AMENDMENTS TO THE DRAWINGS

REMARKS

This is intended as a full and complete response to the Office Action dated January 9, 2008, having a shortened statutory period for response set to expire on April 9, 2008. Please reconsider the claims pending in the application for reasons discussed below.

FIG. 3

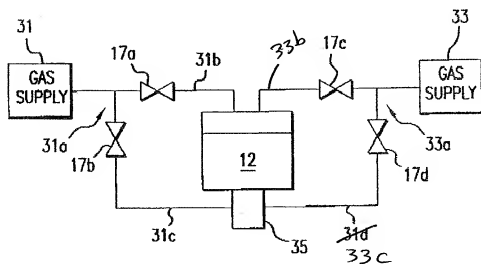
Figure 3 has been amended to include labels for feed lines 33b and 33c as required by the Examiner. No new matter has been added.

In the Drawings, Figure 3 has been amended to include labels for feed lines 33b and 33c. No new matter has been added.
